R645-301-412 RECLAMATION PLAN

Title: <u>Mid Term + Permit Renewal Response</u>	PERMIT NUMBER: <u>ACT/007/011</u>
Description:	PERMIT CHANGE #: <u>DO 92A & 94C</u>
	MINE: <u>Hiawatha</u>
	PERMITTEE: <u>U.S. Fuel</u>

Title: <i>South Fork Culvert Removal</i>	PERMIT NUMBER: <i>ACT/007/011</i>
Description:	PERMIT CHANGE #: <i>94I</i>
	MINE: <i>Hawatla</i>
	PERMITTEE: <i>U.S. Fuel</i>

RE: **Permit Change Application -- Portable Crushing and Screening Plant Location; U.S. Fuel Company, Hiawatha Mine, Permit ACT/007/011.**

PROPOSED ROCK GABION #5

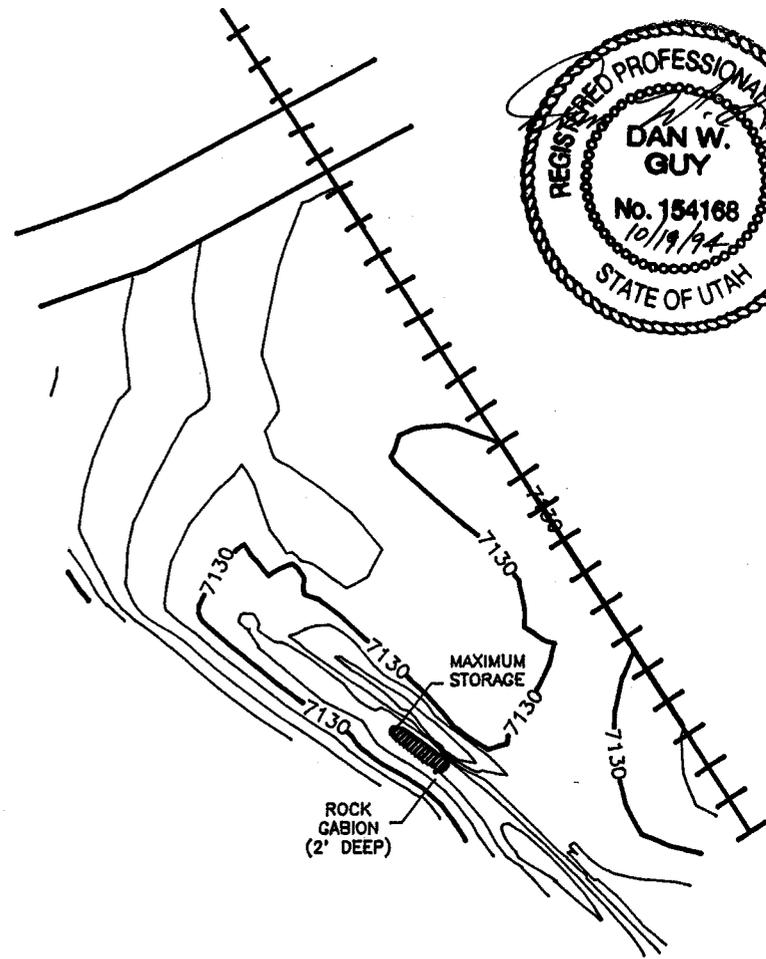
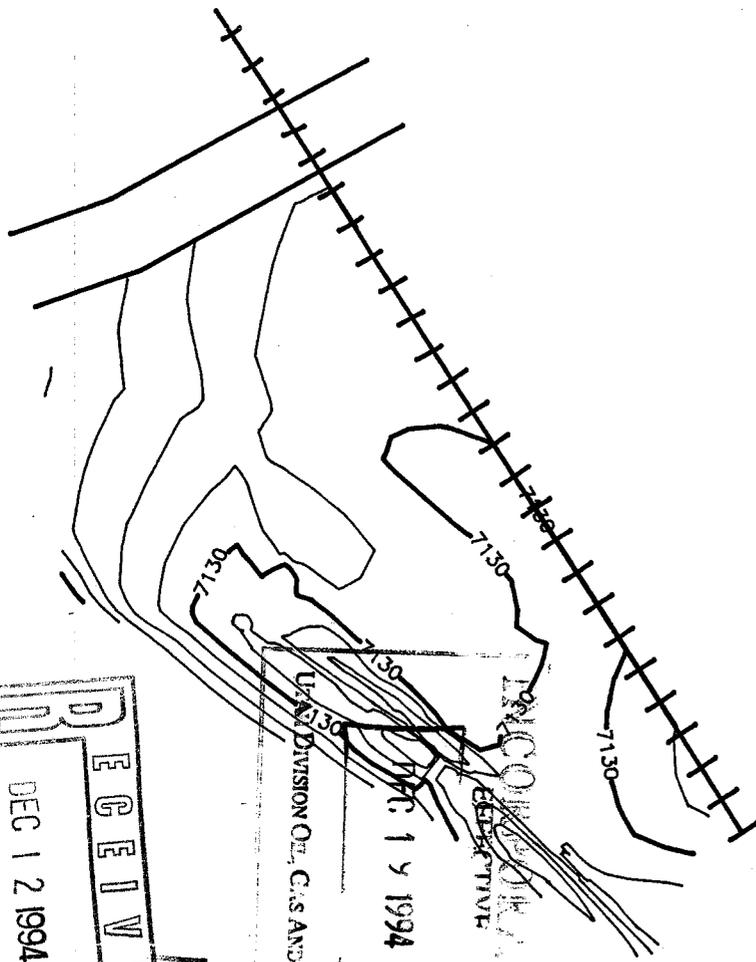
Due to the extremely small area draining from the Water Truck Fill Location, Catch Basin No. 5 will be eliminated and replaced with a rock gabion discharge structure. The area will remain designated as a Small Area Exemption; however, runoff treatment will be through the gabion rather than by the basin.

The gabion will be installed at the location of the existing dam for the basin, as shown on the attached drawing. Water impounded by the gabion will be less than 0.0025 acre-feet; therefore, this structure will no longer be considered an impoundment.

NOTE: CATCH BASIN #5 TO BE REPLACED WITH ROCK GABION BASKET DISCHARGE.
 ROCK GABION CAPACITY TO BE LESS THAN .0025 AC.FT.

FIGURE 1

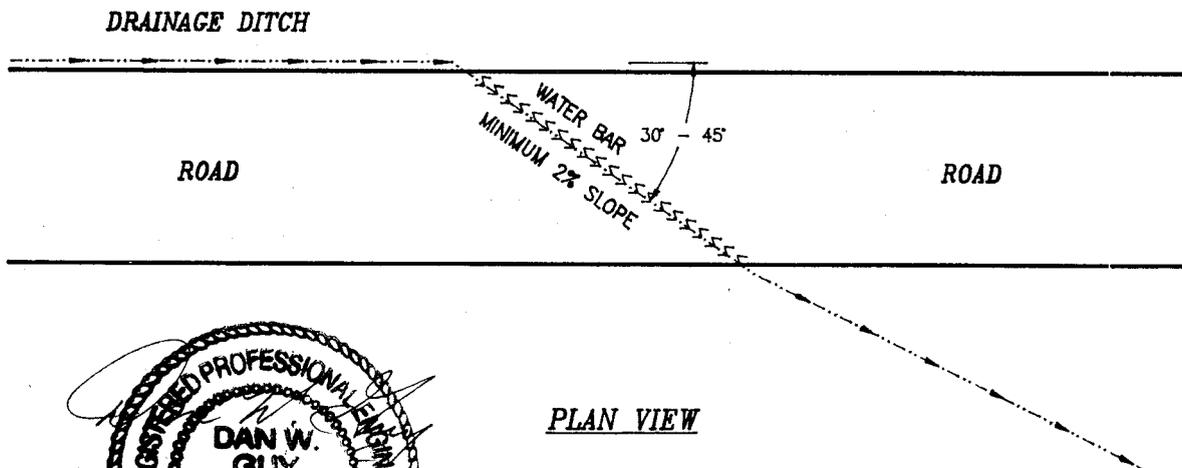
Certain, essential culverts will be left in place; however, all non-essential culverts will be removed. In areas where culverts are removed, road drainage control will be provided by construction of water bars as shown on Exhibits V-19 and V-20. Water bars will be constructed according to the design shown on Figure 1 of this Appendix.

The maximum depth of the proposed water bars will be 1.0' as shown on Figure 1. As indicated on Table 1, this would be adequate to convey the flows from most of the replaced culverts, but not from all. The minimum spacing of 1150' for the water bars would allow for a maximum drainage area of 40 acres, and provide for flow depths below 1.0', while maintaining runoff velocities below the erosive level of 5.0 fps. It was therefore decided that the water bars would be placed at intervals not to exceed 1000' to ensure a conservative runoff estimate. In many cases, the interval will be less due to specific ground conditions as described in the following sections.

The designed water bars, as shown in Figure 1, are therefore considered adequate to safely convey the expected runoff from a 100 year-6 hour precipitation event, as required.
